SERVICE BULLETIN

APPLICABILITY: 2001MY and later Impreza WRX
SUBJECT: Modification to Rear Brake Caliper

NUMBER: 06-36-06
DATE: 06/23/06

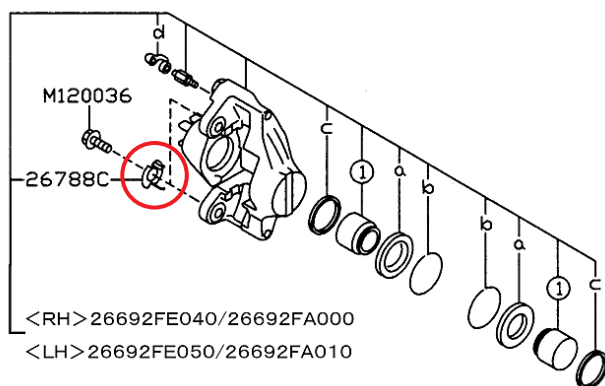
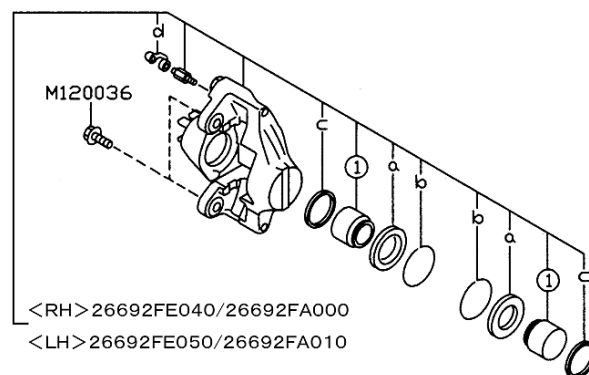
A production change was made to the rear brake caliper on 01MY and newer Impreza WRX. The washer between the caliper body and the backing plate has been discontinued. A change has been made to the caliper body to maintain the correct geometry, although the part numbers have not changed.

Old Disk Brake Kit: 26692FE040/050 (LH/RH)

New Disk Brake Kit: 26692FE040/050 (LH/RH)

Note: Though there were design changes made to this part, the part numbers remain the same.
